# Access Compliance Report

## Public Rights-of-Way

### (Curb Ramps)

Intersection ID: N/A	Main Street: N_TRYON_ST	Cross Street: US-29	Location: N
ADA ID: 3D3598B1EB24	Ramp Type: BlendTrans2	Initial Pass/Fail: Pass	Overall Compliance: No
Severity Score: 5			
Codes/Mitigation Info/Possible Solution		Field Measurements/Component Compliance

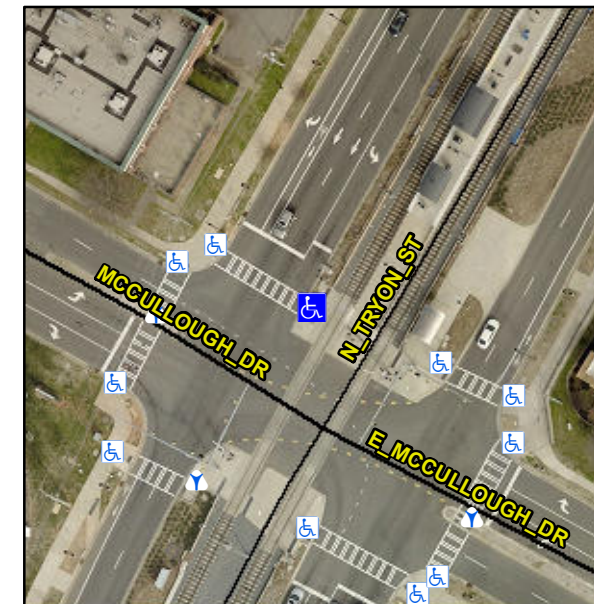
**R304.2.3**

Compliance	Description	Data	Compliance	Description	Data
N/A	Ramp Length (in)	91.0	Yes	BlendTrans Slope (%)	0.2
Yes	Ramp Width (in)	119.0	Yes	BlendTrans XSlope (%)	1.3
Yes	Flare Type <b>Curbed_NoWalkSurface</b>		No	Flare Type <b>Curbed_WithWalkSurface</b>	
N/A	Flare Slope LT (%)	N/A	N/A	Flare Slope RT (%)	N/A
N/A	Flare Traversable LT?	No	N/A	Flare Traversable RT?	No
N/A	Landing Length (in)	N/A	Yes	DWS Provided?	Yes
N/A	Landing Width (in)	N/A	Yes	DWS Contrast?	Yes
N/A	Landing Slope (%)	N/A	Yes	DWS Length (in)	24.0
N/A	Landing X Slope (%)	N/A	Yes	DWS Full Width?	Yes
N/A	Landing Curb? (Y/N)	No	Yes	DWS Offset (in)	0.0
N/A	Shared Landing?	No			
Yes	Gutter Ponding?	No	Yes	Gutter Slope (%)	1.8
Yes	Gutter Lip Ht (in)	0.0	Yes	Gutter X Slope (%)	0.9
N/A	Painted X Walk1?	Yes	N/A	Painted X Walk2?	N/A
	X Walk 1 Direction	To NW		X Walk 2 Direction	N/A
	X Walk 1 Width (in)	101.0		X Walk 2 Width (in)	N/A
	X Walk 1 Slope (%)	0.2		X Walk 2 Slope (%)	N/A

**Remove & Replace Curbed Edge.**
